**HISTORIC PRESERVATION COMMISSION STAFF REPORT**

<b>Address:</b>	37 Lenox St, Chevy Chase	<b>Meeting Date:</b>	8/16/2006
<b>Resource:</b>	Contributing Resource Chevy Chase Village Historic District	<b>Report Date:</b>	8/9/2006
<b>Applicant:</b>	Jerome Powell (Stephen Muse, AIA)	<b>Public Notice:</b>	8/2/2006
<b>Review:</b>	Preliminary Consultation	<b>Tax Credit:</b>	partial
<b>Case Number:</b>	NA	<b>Staff:</b>	Tania Tully

**PROPOSAL:** for alterations and additions

**RECOMMENDATION:** Revise and return for another Preliminary

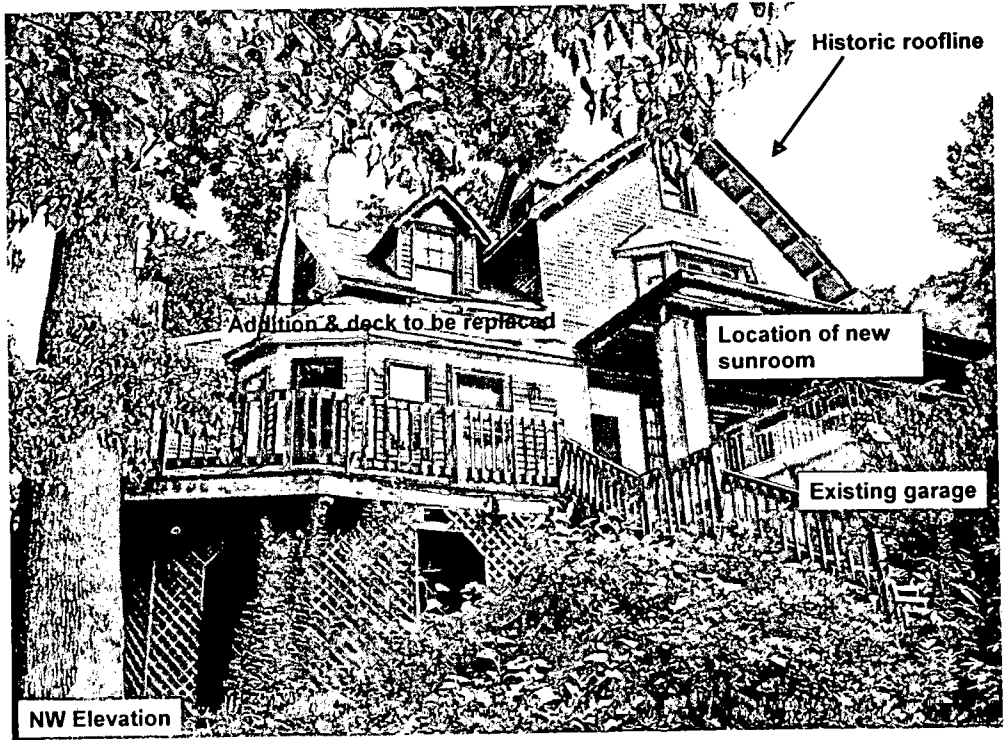
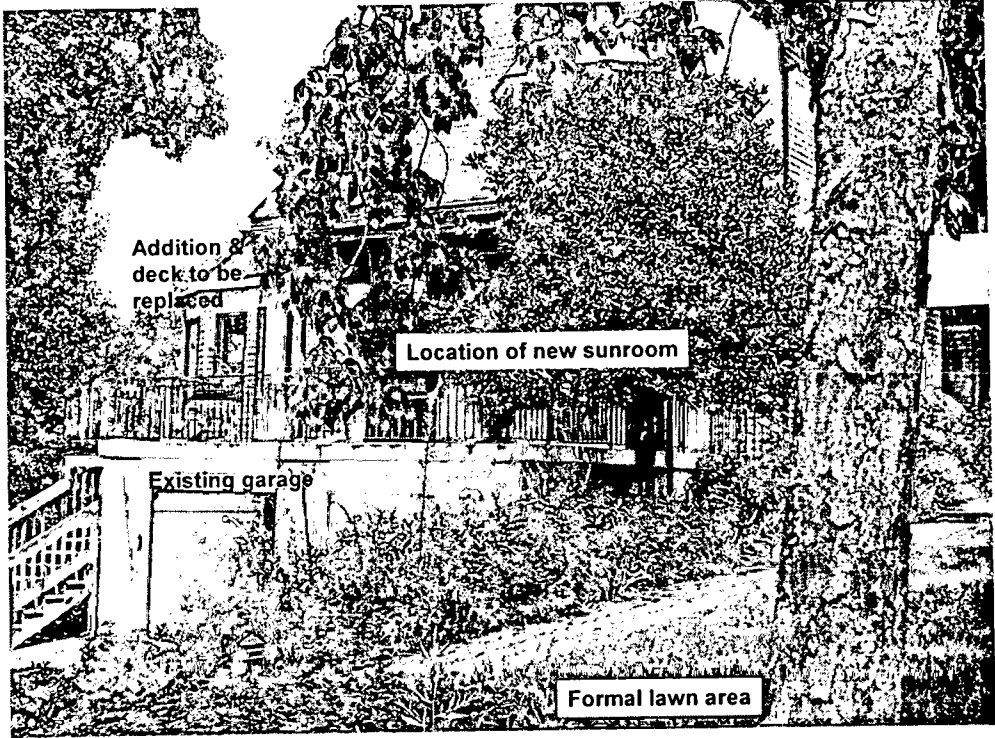
Hedges removed from this location for new drive way would be relocated to existing driveway location.

Hedges removed from new drive way location would be relocated to existing driveway at this location.

Location of lawn surrounded by a low seat wall.

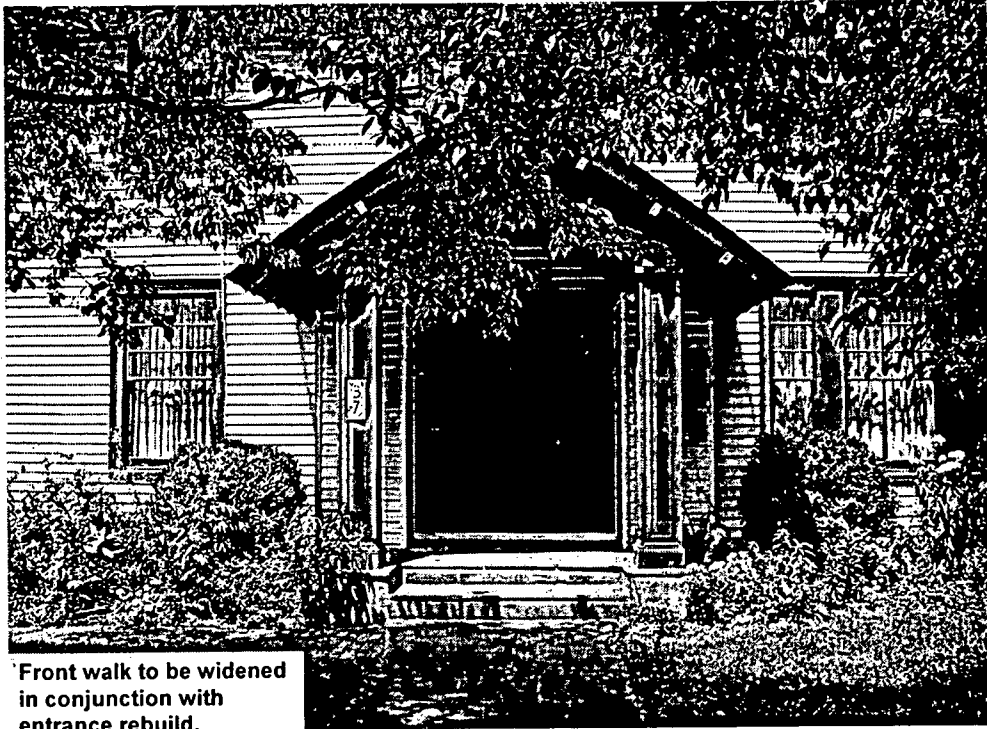
Aluminum siding to be removed

Closet bump-outs to be removed

Brick walk to be removed

Entry structure to be rebuilt

Front walk to be widened  
in conjunction with  
entrance rebuild.
